APPLICATION NO.	FILING DATE	FIRST NAMED INVENTOR	ATTORNEY DOCKET NO.	CONFIRMATION NO.
10/611,551	06/30/2003	Susan I. Shelso	10527-794001 / 02-260	5002

Office Action Summary	Application No. 10/611,551	Applicant(s) SHELSON, SUSAN I.	
	Examiner Melanie Tyson	Art Unit 3773

Claim Rejections - 35 USC § 103

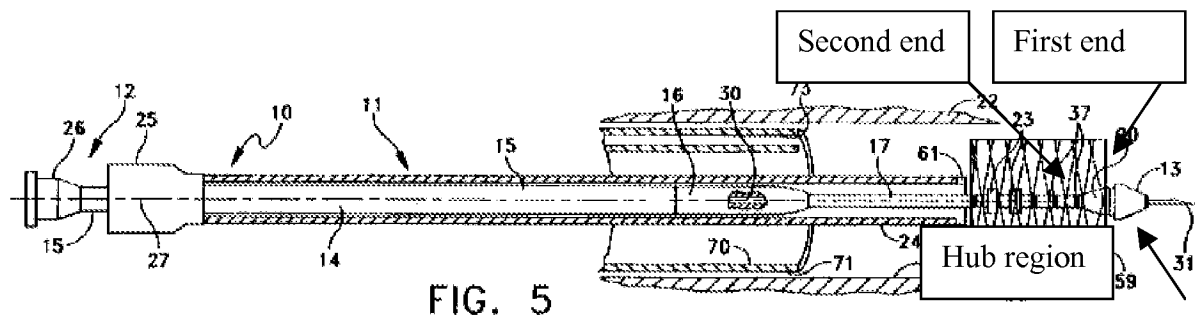
3. Claims 11-13, 16-24, 26, 27, 29, and 30 are rejected under 35 U.S.C. 103(a) as being unpatentable over Ravenscroft (Patent No. 5,702,418). Ravenscroft discloses a stent delivery system (see entire document) comprising a catheter having an inner shaft (31), a retractable sheath (24), at least one radiopaque grip member (for example, see column 7, lines 42-45) having a substantially tapered body region (tapered portion of 13) and a hub region (enlarged portion of 13) having an outer diameter greater than the outer diameter of the first end of the body region, and an expandable stent (20) comprising a plurality of struts disposed about the inner shaft and engaged to at least a portion of the body region, wherein during use, the hub region is positioned proximal to

the stent (20), and the outer diameter of the hub region is greater than the outer diameter of the stent (20) when the stent (20) is in an unexpanded state (for example, see Figures 1, 4, 5, and illustration below).

Applicant argues that Ravenscroft fails to disclose a hub region that is “positioned **proximal** to the stent.” Claims in a pending application should be given their broadest reasonable interpretation. The term “proximal” has been interpreted as being “situated close to” (for example, see Merriam-Webster Online Dictionary), in that the hub region is situated close to the stent, and Ravenscroft discloses the configuration as claimed (for example, see Figures 1 and 5). Applicant further argues that Ravenscroft fails to disclose the stent directly contacts the hub region, however, such a modification would have been obvious as a matter of design choice (see new rejection above). With respect to applicant's argument that it would not be physically possible to place both Ravenscroft's stent and his outer sheath in abutment with the hub region, Ravenscroft does not disclose that the sheath abuts the hub region's entire inner surface or any portion thereof. Applicant cites Figure 1, however, Figure 1 illustrates that the sheath engages the outermost portion of the hub region with a space between the outermost portion and the inner portion of the inner surface. Since the stent has a diameter smaller than the sheath during use, it is physically possible for the stent to directly contact an inner portion of the inner surface of the hub region while the sheath engages the outermost portion of the hub region as illustrated.
